**Lee Nuclear Station Units 1 and 2  
Description, Scope of Changes, and FSAR Impacts due to Plant Relocation and  
Additional Design Enhancements**

**Description and Rationale for Lee Nuclear Station Units 1 and 2 Relocation and  
Additional Design Enhancements**

FIGURE 2.4.3-227

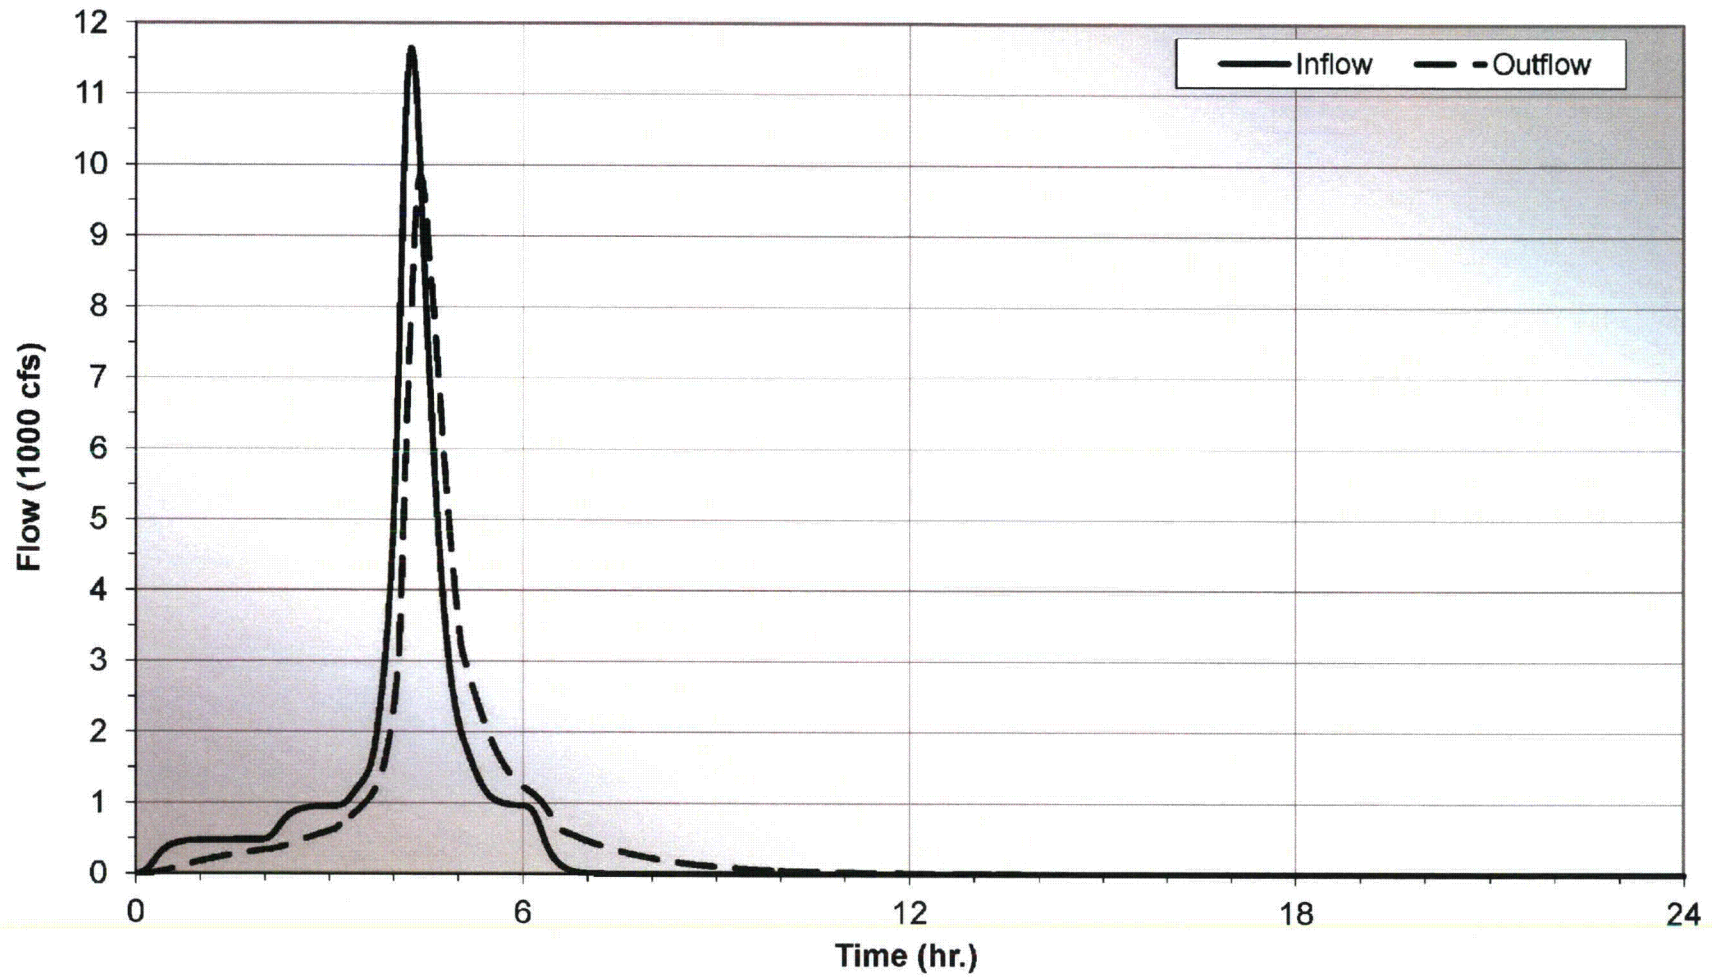
However, the 72-hr. tail end peaking storm event resulting in a peak PMF runoff of ~~18,813~~18,937 cfs and a routed discharge of ~~8249~~8386 cfs provided the controlling water surface elevation. The peak runoff in the Upper Arm Dam during the 72-hr. tail end peaking storm event will be ~~3446~~3577 cfs with a peak discharge of ~~3381~~3549 cfs. The resulting Make-Up Pond B flow hydrograph for the 72-hr. tail end peaking storm event is shown in Figure 2.4.3-227. Temporal distribution of the PMP is discussed in Subsection 2.4.3.1.

49. COLA Part 2, FSAR Chapter 2, Figure 2.4.3-227 is revised as follows:

FIGURE 2.4.3-228

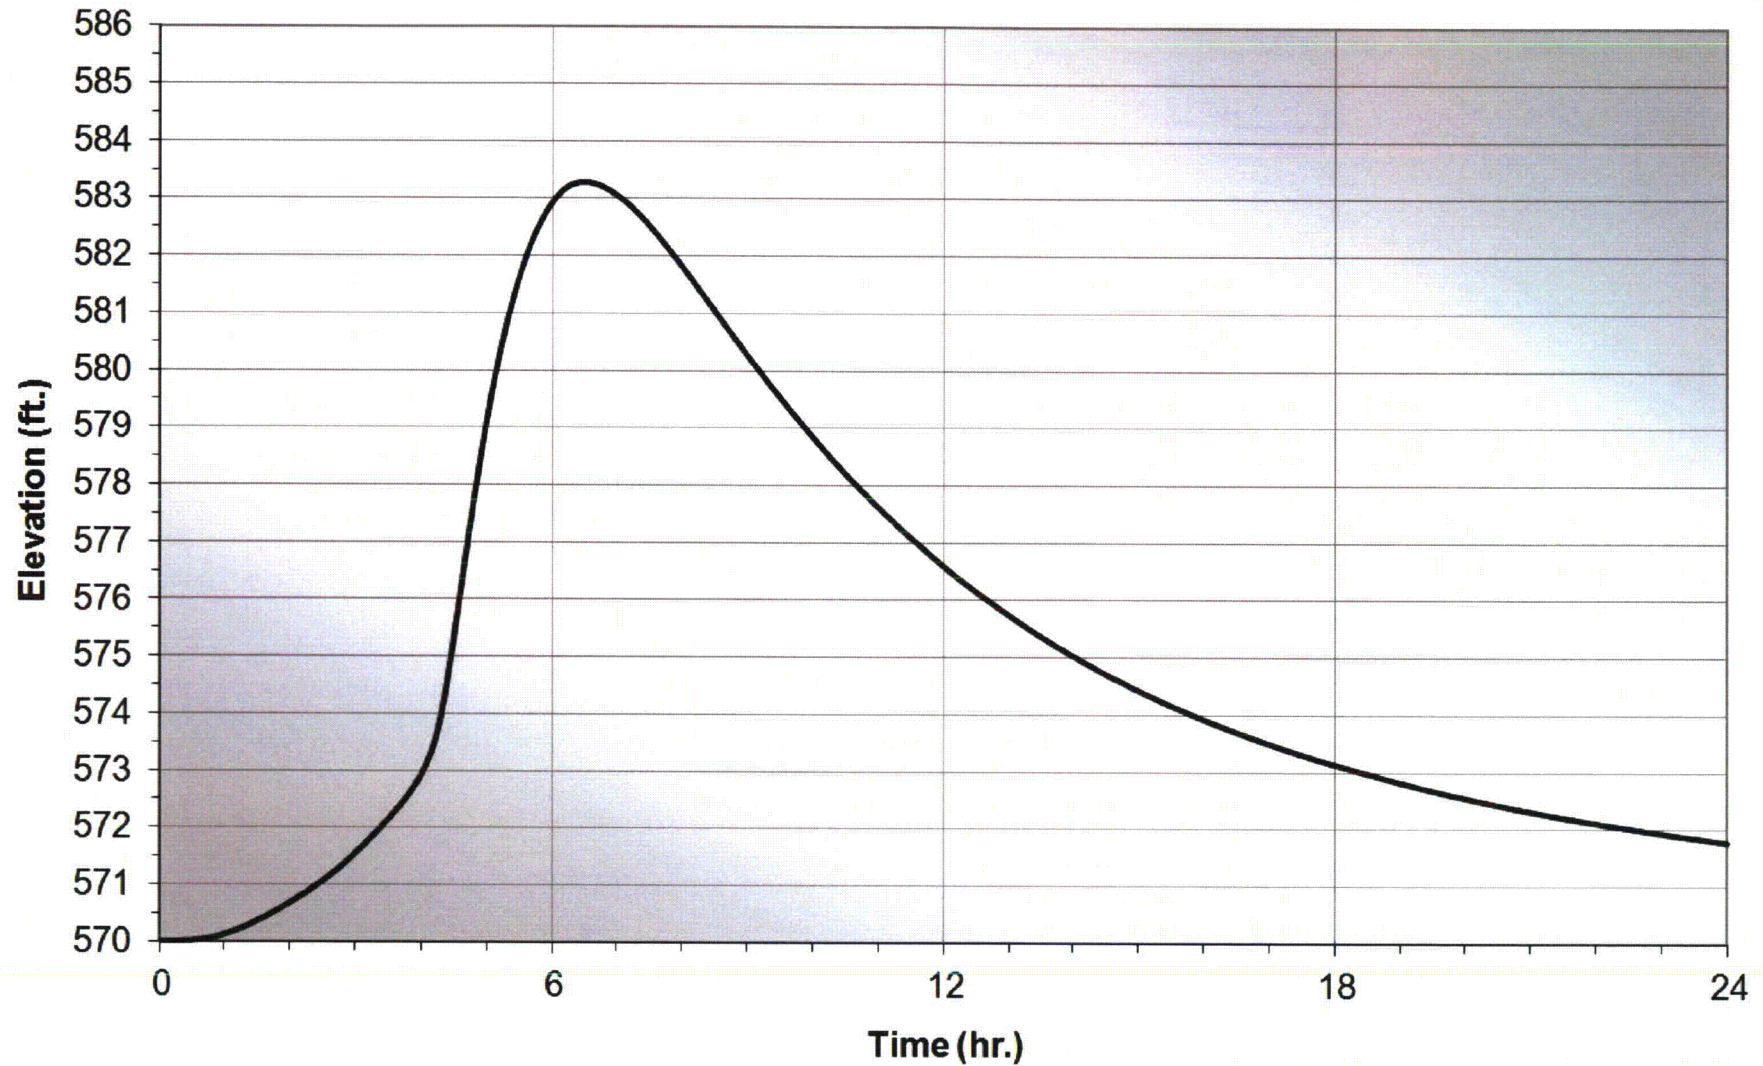
50. COLA Part 2, FSAR Chapter 2, Figure 2.4.3-228 is revised as follows:

FIGURE 2.4.3-230

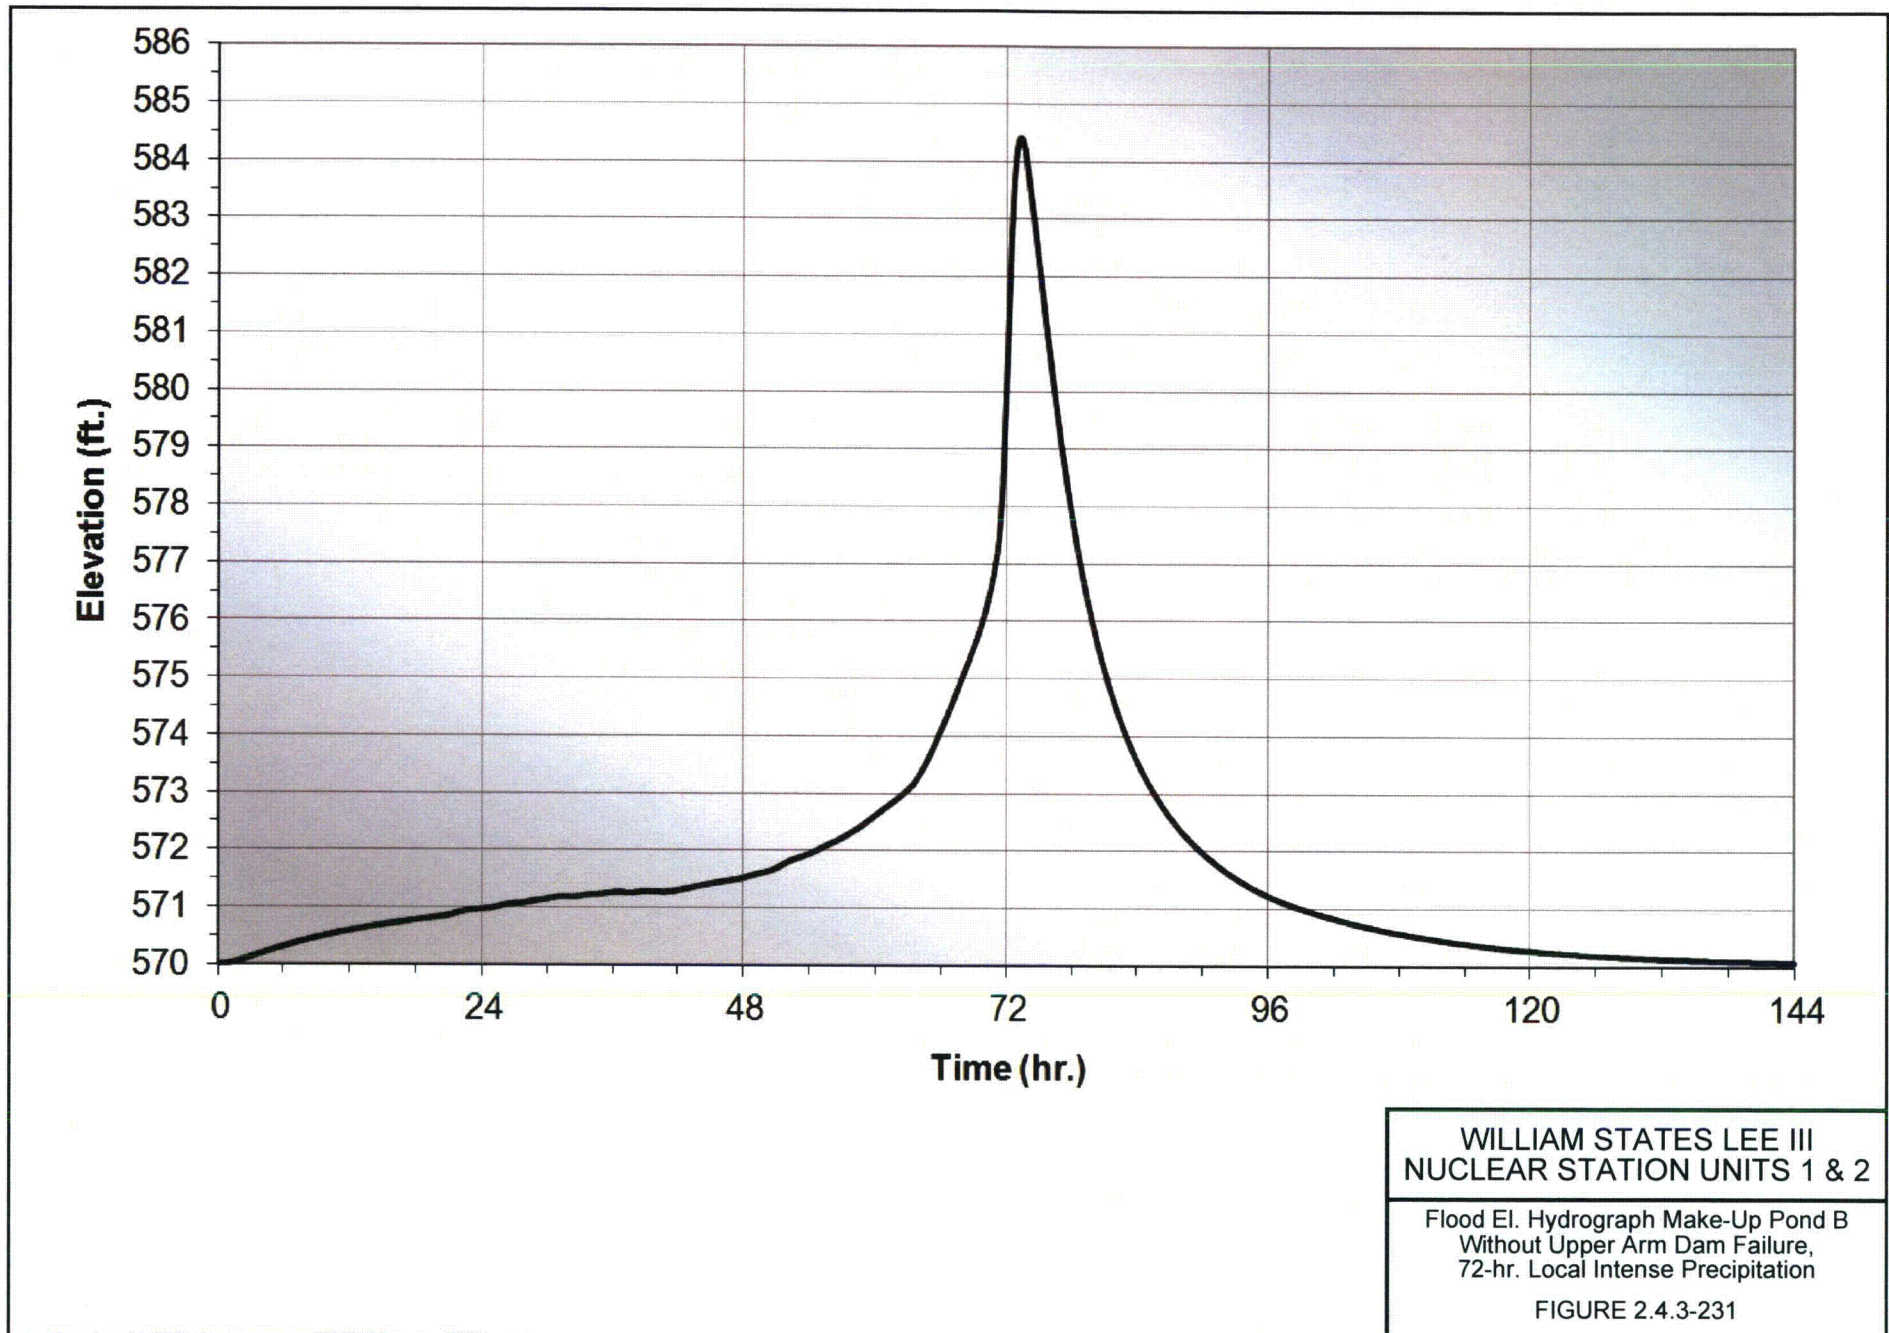
51. COLA Part 2, FSAR Chapter 2, Figure 2.4.3-230 is revised as follows:

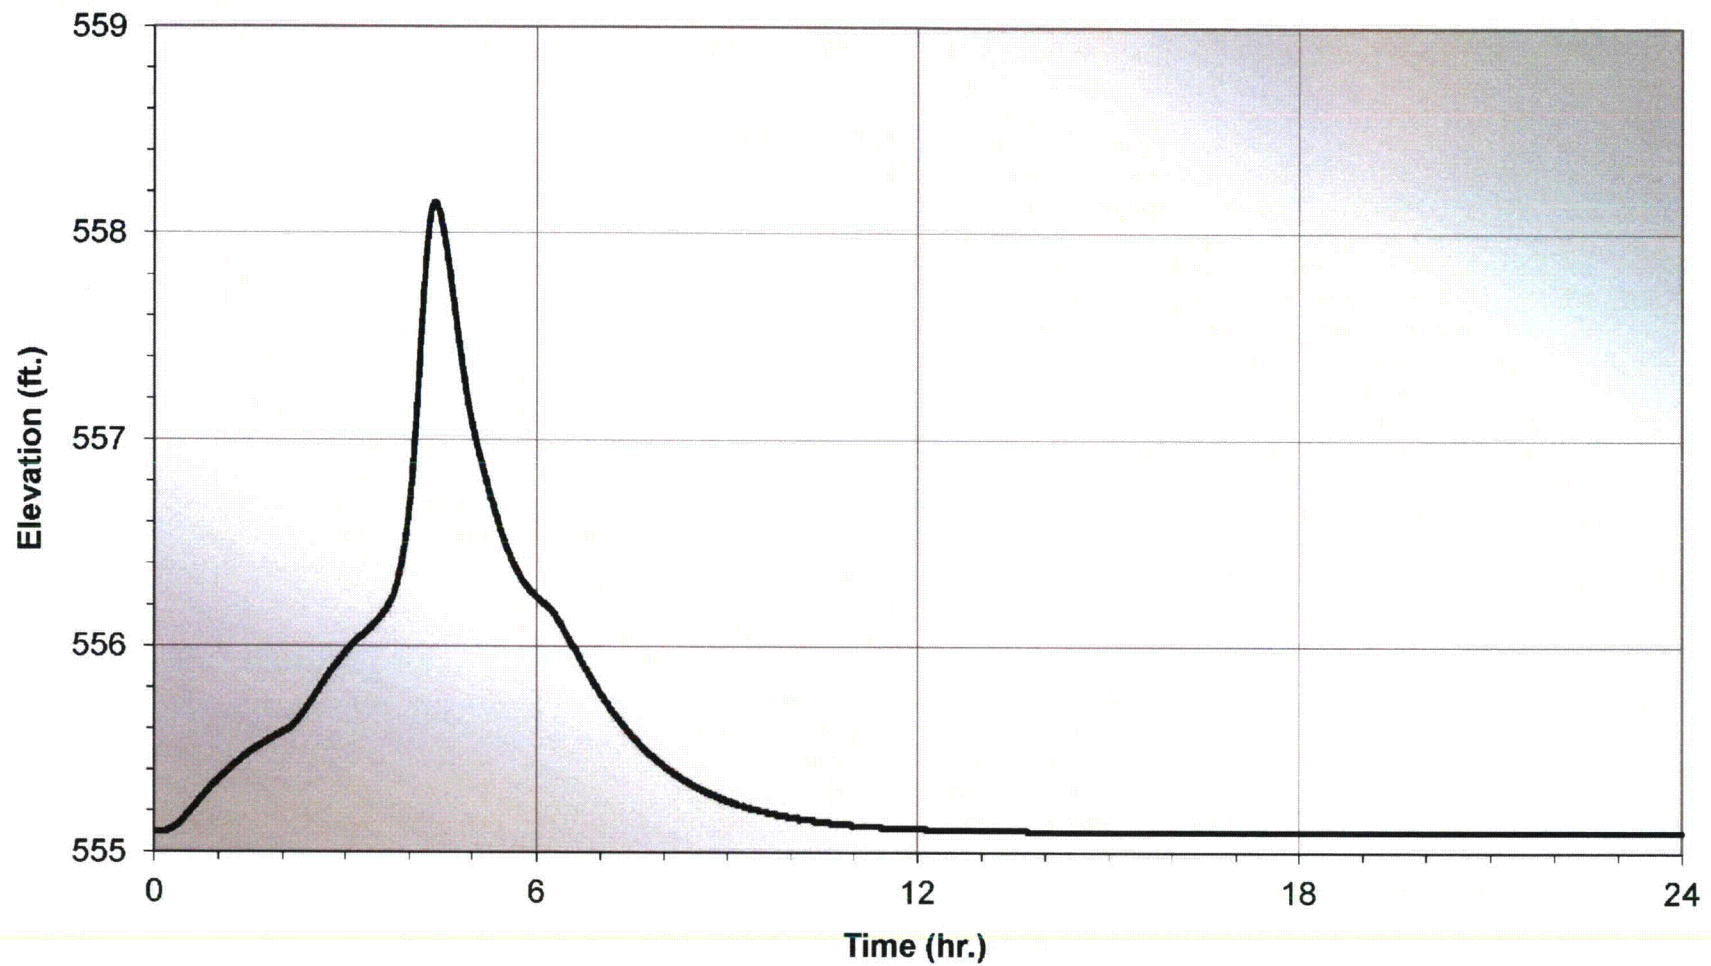
Subsection 2.4.4.3 addresses coincident wind wave activity for Make-Up Pond B. The maximum water surface elevation of Make-Up Pond B without considering Upper Arm Dam failure, resulting from the 6-hr. two-thirds peaking storm event modeled with a 51-min. time step, was found to be 583.27583.29 ft. The elevation hydrograph is provided in Figure 2.4.3-230. The maximum water surface elevation of Make-Up Pond B resulting from the 72-hr. tail end peaking storm event modeled with a 401-min. time step was found to be 584.09584.40 ft., including discharge from the Upper Arm. The maximum is produced by the condition that the Upper Arm Dam culvert is not functional, but does include overtopping flows. The peak water surface elevation in the Upper Arm Dam for the 72-hr. tail end, peaking storm will be 592.13592.28 ft. The ridge on the east side of the Upper Arm Dam separates the Upper Arm and the site, as illustrated in Figure 2.4.3-201. At elevations above 590.0 ft., discharge across the dam embankment flows directly into Make-Up Pond B. Nevertheless, peak water surface elevations for the Upper Arm are below the station's safety-related plant elevation of 593 ft. Therefore, water surface elevations for the Upper Arm will not encroach upon site SSC's. The elevation hydrograph for Make-Up Pond B is provided in Figure 2.4.3-231.

52. COLA Part 2, FSAR Chapter 2, Figure 2.4.3-231 is revised as follows:

FIGURE 2.4.3-233

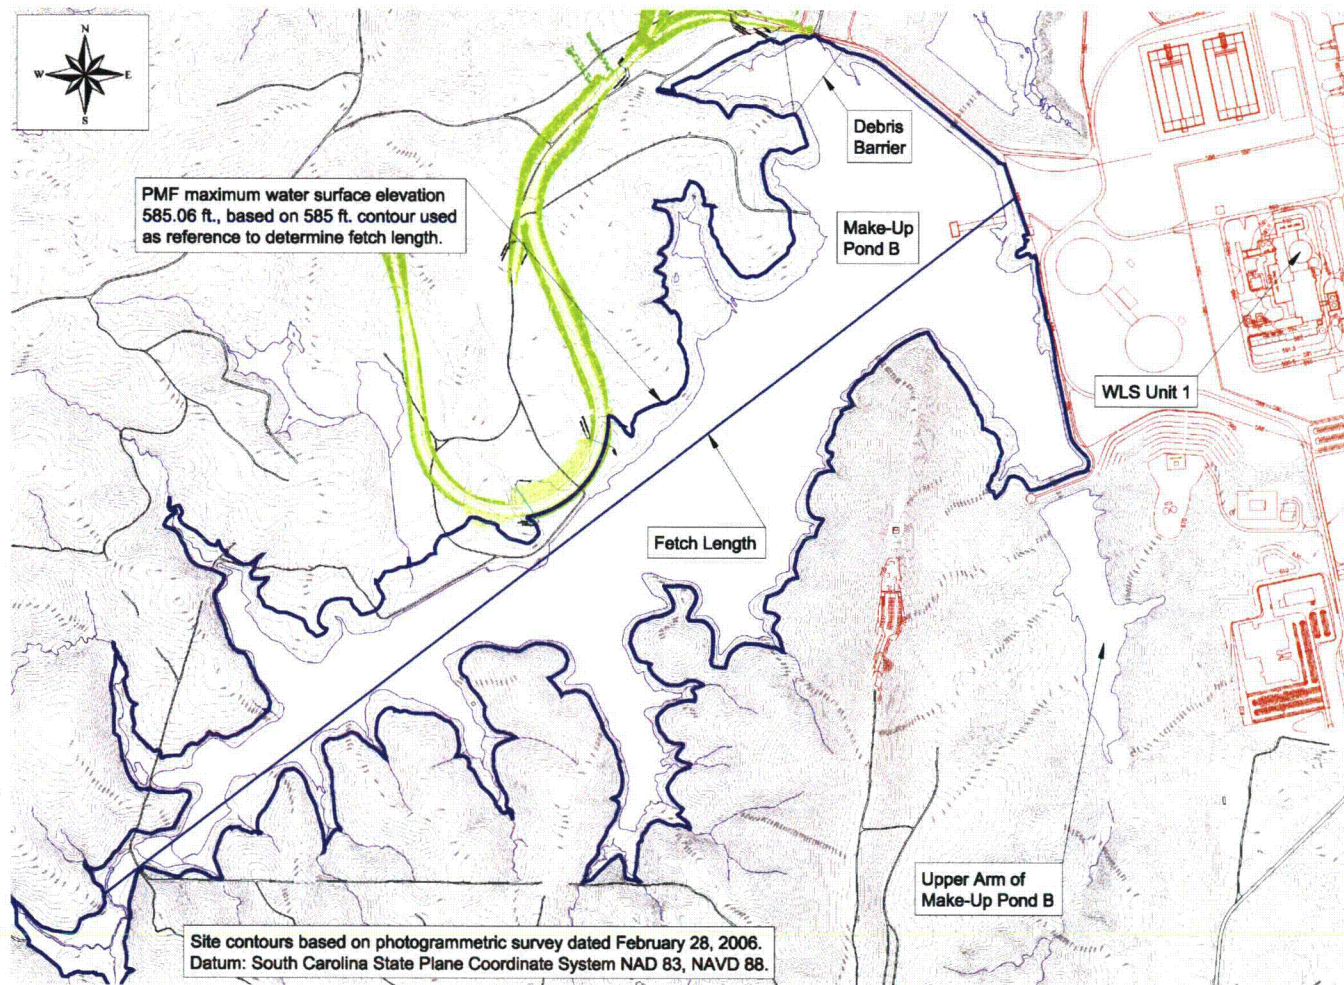
53. COLA Part 2, FSAR Chapter 2, Figure 2.4.3-233 is revised as follows:
